STAFF RECOMMENDATION

1514 Cedar Lane

Application: New Construction-Outbuilding

District: Belmont-Hillsboro Neighborhood Conservation Zoning Overlay

Site Layout Plan

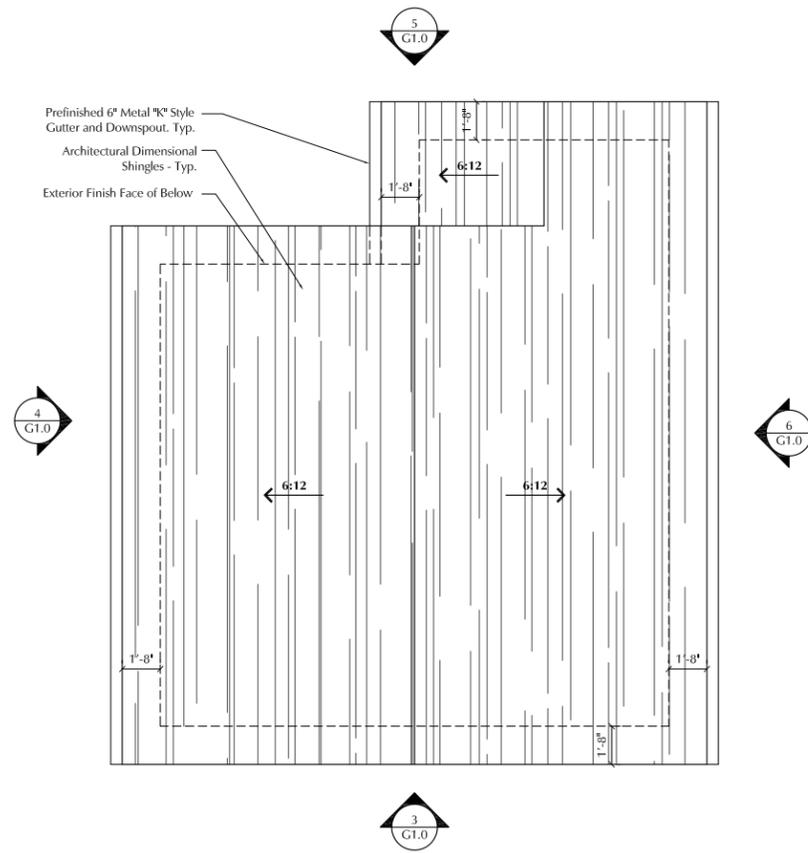
MINIMUM	PROPOSED
Building located towards rear of lot	-	Yes
Space between principal building and garage	20'	~10'
Rear setback – garage doors face alley	5'	5'
Interior right side setback	3'	3'
Interior left side setback	3'	~44'
How is the building accessed?	-	From alley
Two different doors rather than one large door (if street facing)?	-	N/A

The guidelines state that *‘there should be a minimum separation of 20’ between the principal structure and the DADU or outbuilding’*. The applicant is proposing ten feet (10’) of separation between the home and the outbuilding. Staff finds that this is appropriate because the lot is shallow, at one-hundred and forty feet (140’) deep, the 2018 rear addition was modest and its depth was minimized by going wider than the house. The Commission has allowed applicants to reduce the distance between the house and outbuilding if the lot is less than one-hundred-fifty feet (150’) deep and the project does not include a large addition, resulting in a house that does not meet the historic context.

Staff recommends approval with the condition that staff shall review and approve the windows, doors and garage doors, finding the proposed new construction meets the design guidelines for the Belmont-Hillsboro Neighborhood Conservation Zoning Overlay.

Drawings:
Garage Elevations
Date:
05.22.2020

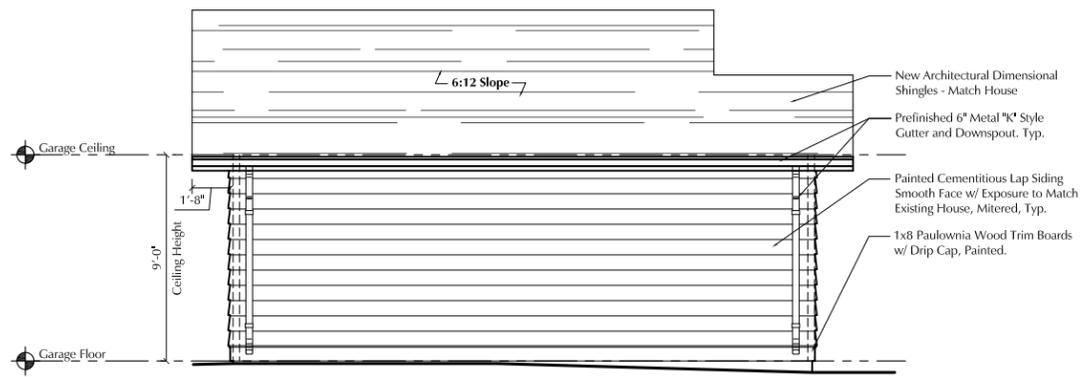
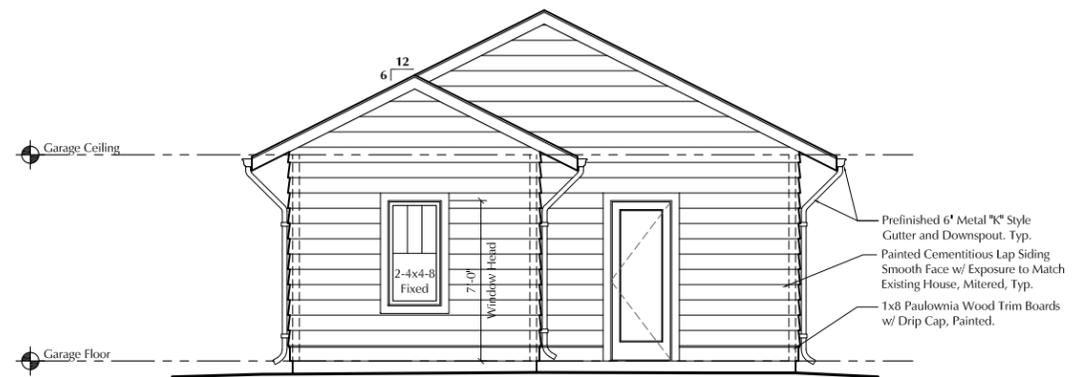
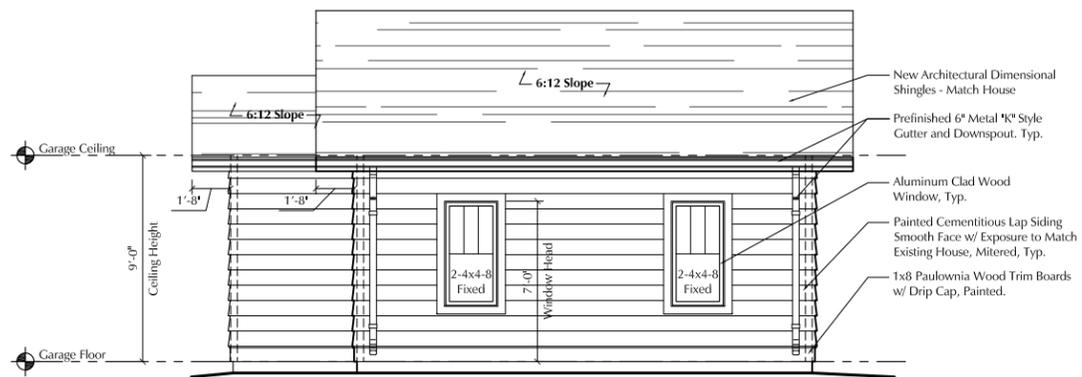
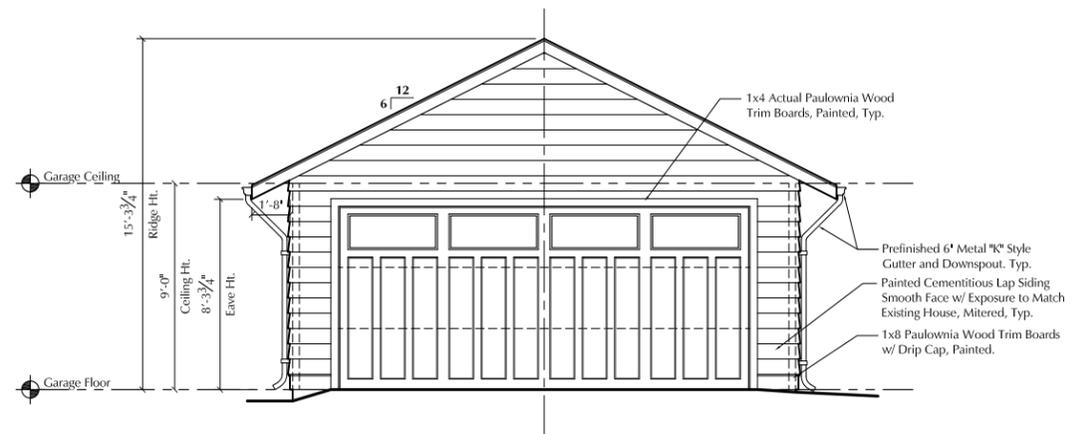
The proposed ridge height will be approximately fifteen feet (15') tall from grade which is less than the twenty-three-foot (23') tall house and less than the twenty-five foot (25') maximum. The eave height will be an average of about eight feet (9') tall from grade, which meets the guidelines.

Proposed Element	Proposed Form	Typical of district?
Primary form	Gable	Yes
Primary roof slope	6/12	Yes

Proposed	Color/Texture	Needs final approval?
Foundation	Slab	n/a	No
Cladding	Lap siding, smooth side, reveal to match existing house	Unknown	No
Roofing	Architectural shingles	Match house	No
Windows	Aluminum clad	Unknown	Yes
Doors	Not indicated	Unknown	Yes
Garage door	Not indicated	Unknown	Yes
